Control No. PCN-23142

PRODUCT/PROCESS CHANGE NOTIFICATION

An existing qualified leadframe supplier, Hua Yang, will be added as an alternative leadframe supplier for 170x210 mil leadframe to be used for the TinySwitch SMD-8 products listed below.

Existing Leadframe Design (mm)

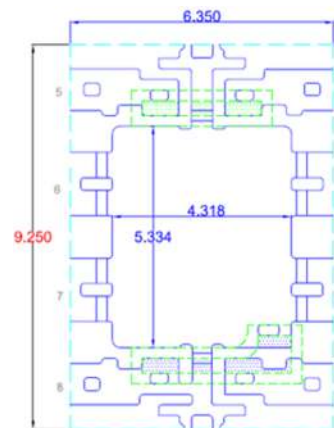
There will be some small dimensional changes to the inner lead features that will not affect fit, functionality or performance of the product. The plastic body length will also change as shown in the figure, but the new dimension is still within our datasheet package drawing tolerances.
